TIE-LINE 637 WOOD-TO-STEEL PROJECT
MINOR PROJECT REFINEMENT
REQUEST FORM

Date Requested:	April 30, 2014	Report #:	004
Date Approved:	May 5, 2014	Approval Agency:	County of San Diego Simon Preserve (TA-1, TA-2, TA-3). No other agency approval required for TA-4 and TA-5.
Property Owner(s):	SDG&E Right-of-Way (ROW), Private, and the County of San Diego	Location/Milepost:	Turn-around area locations identified in Table 1
Land Use/ Vegetative Cover:	The proposed impact area occurs within bare ground and disturbed habitat (existing non-approved project access roads), and non-native grassland.	Sensitive Resources:	Cultural and Aquatic Resources (see Attachment A – Resources Map)
Refinement / Modification From (check all that apply):			
<input type="checkbox"/> Permit	<input type="checkbox"/> Plan/Procedure	<input type="checkbox"/> Specification	<input type="checkbox"/> Drawing
<input type="checkbox"/> Mitigation Measure (MM)			
<input checked="" type="checkbox"/> Other: Turn-around areas

Figure 4: Aerial Image of proposed turn-around area (TA-4) southeast of Structure Nos. P91 and P92. Segment of overland travel route is shown as orange line.

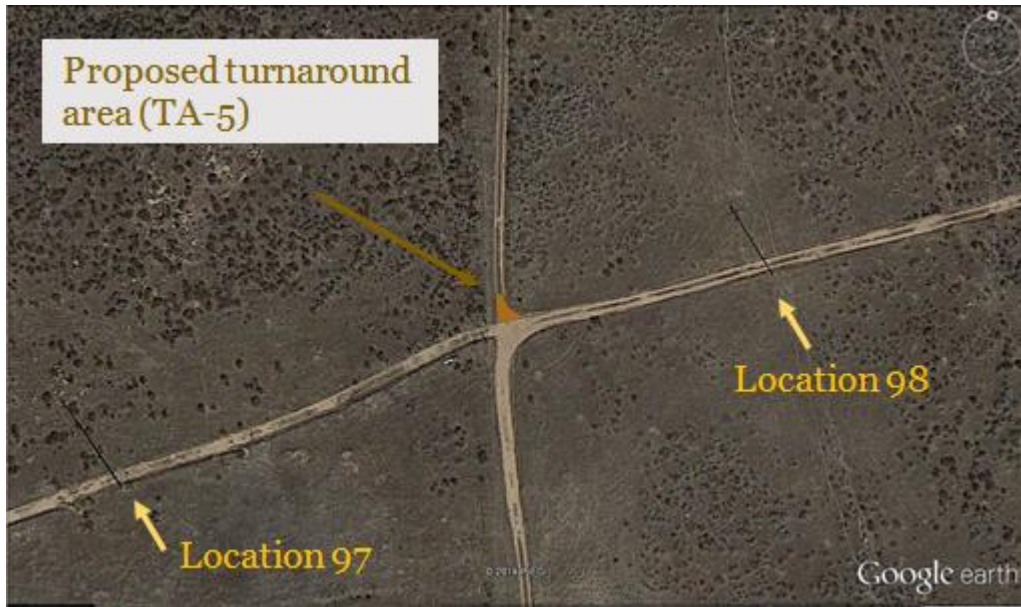
Turn-around area No. 4 (TA-4) is approximately 90 feet long, with a width varying from 15 to 30 feet and is located west of the overland travel access entrance to Structure No. P92 on the north side of the existing main project access road. TA-4 will result in approximately 1,315 square feet of temporary impacts to bare ground habitat located within an existing access road, as shown in Figure 4 and Photograph No. 4.

The impact area for TA-4 occurs within bare ground within an existing maintained dirt road and would result in approximately 1,315 square feet of temporary impacts to bare ground habitat. No vegetation trimming is anticipated to occur; therefore, no impacts to sensitive biological resources are anticipated to occur as a result of the proposed activities.

The proposed temporary turn-around area TA-4 occurs directly adjacent to a stream that is likely considered jurisdiction by Federal and State aquatic resource agencies. The turn-around area is located near the headwaters of an unnamed tributary of San Vicente creek, which flows into the San Diego River and ultimately, the Pacific Ocean (a traditionally navigable waterway). An investigation into jurisdictional waters within the project right-of-way conducted by RECON in spring of 2014 concluded that flows upstream of the proposed turn-around area were erosional in nature within uplands and, therefore, exempt from jurisdiction. Regardless, a likely jurisdictional ephemeral drainage was observed directly southwest of proposed turn-around area TA-4. The turn-around area is located near the headwaters of the creek and, due to disturbance by road traffic; clear indicators of jurisdiction are obscured. In order to avoid impacts to the downstream jurisdictional drainage, the following avoidance and minimization measures (which are already being used on the project where aquatic resources are present) should be followed:

- No grading within the turn-around area.
- No deposition of fill materials (including soil [native or imported], gravel, etc.) within the proposed turn around area.
- BMPs would be installed and maintained downstream of the turn-around area and would be placed to capture sediment without significantly impeding hydrologic flows.
